Access Compliance Report

Public Rights-of-Way

(Curb Ramps)

Intersection ID: 45164	Main Street: ELESSAR_PL	Cross Street: ARAGORN_LN	Location:	S
ADA ID: 122FD70469FC	Ramp Type: PerpDiag	Initial Pass/Fail: Fail	Overall Compliance: No	Severity Score: 37.5
Codes/Mitigation Info/Possible Solution		Field Measurements/Component Compliance

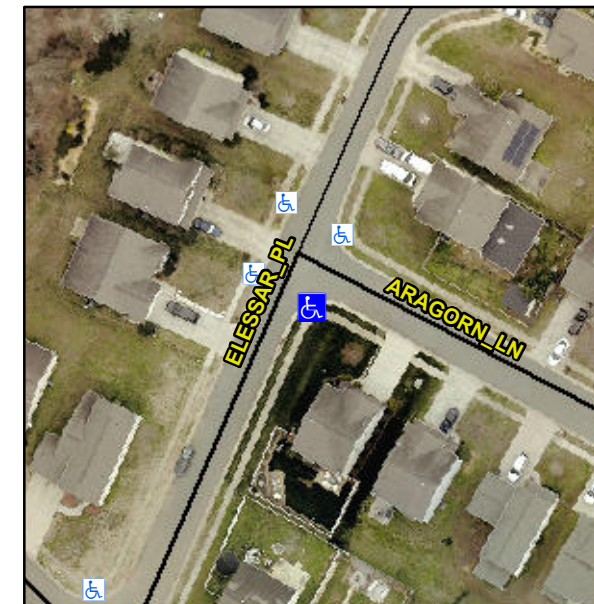
R304.2.2, R304.5.3

Compliance	Description	Data	Compliance	Description	Data
N/A	Ramp Length (in)	48.0	No	Ramp Slope (%)	10.6
Yes	Ramp Width (in)	48.0	No	Ramp XSlope (%)	7.6
N/A	Flare Type LT	N/A	N/A	Flare Type RT	N/A
N/A	Flare Slope LT (%)	N/A	N/A	Flare Slope RT (%)	N/A
N/A	Flare Traversable LT?	N/A	N/A	Flare Traversable RT?	N/A
N/A	Landing Length (in)	N/A	N/A	DWS Provided?	N/A
N/A	Landing Width (in)	N/A	N/A	DWS Contrast?	N/A
N/A	Landing Slope (%)	N/A	N/A	DWS Length (in)	N/A
N/A	Landing X Slope (%)	N/A	N/A	DWS Full Width?	N/A
N/A	Landing Curb? (Y/N)	N/A	N/A	DWS Offset (in)	N/A
N/A	Shared Landing?	N/A			
N/A	Gutter Ponding?	N/A	N/A	Gutter Slope (%)	N/A
N/A	Gutter Lip Ht (in)	N/A	N/A	Gutter X Slope (%)	N/A
N/A	Painted X Walk1?	No	N/A	Painted X Walk2?	No
	X Walk 1 Direction	To NE		X Walk 2 Direction	To NW
N/A	X Walk 1 Width (in)	N/A	N/A	X Walk 2 Width (in)	N/A
	X Walk 1 Slope (%)	4.4		X Walk 2 Slope (%)	3.9
	X Walk 1 X Slope (%)	4.0		X Walk 2 X Slope (%)	6.3

Remove & Replace Curb Ramp With Two New Directional Ramps or Equivalent.
